## Application Number: 10/723,046 (Peng et al.) Art Unit 2811 Amendment continued 7 of 18

#### REMARKS-General

FIG. 7 of the applicant's patent application

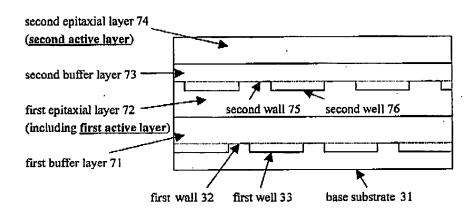
"Claim 9-11 recites the subject matters that a second texture formed on a first epitaxial layer that already comprises an active layer, implying that there are two active layers with the recited second texture there between. It apparently fails to reflect what is described in the specification, in which only one active layer for forming the recited devices is formed above the substrate."

To show clearly the distinctions between Wada and applicant, comparing with FIG 7 of the applicant's patent application, shown as below:

Applicant's second texture is formed on the first epitaxial layer which including a first active layer. Applicant clearly indicates in new claim 24 that "The semiconductor device of claim 1, further comprises a second texture formed on the top of said epitaxial layer."

There are two active layers emitting two lights of different wavelengths in applicant's patent application. Applicant clearly indicates in new claim 25 that "The semiconductor device of claim 24, further comprises a second epitaxial layer grown on the top of said second texture and comprising a second active layer."

Applicant requests reconsideration and withdrawal of the objection, because that applicant <u>did</u> describe <u>two</u> active layers for the recited device. The following is the quotation from the specification of the original patent application for PIG 7: "FIG 7 shows a cross sectional view of epitaxial wafer. First texture comprising well 33 and wall 32 is etched on the top surface of substrate 31. First buffer layer 71 is grown on the first texture of substrate 31. First epitaxial layer 72 comprising first active layer is grown on the top surface of first buffer layer 71."

"Second texture comprising well 76 and wall 75 is patterned by etching on the top surface of first epitaxial layer 72. Second buffer layer 73 is grown on the second texture of first epitaxial layer 72. Second epitaxial layer 74 comprising second active layer is grown on the top surface of second buffer layer 73. Lights of different wavelength emitted from first epitaxial layer 72 and second epitaxial layer 74 are combined and emitted out of device."
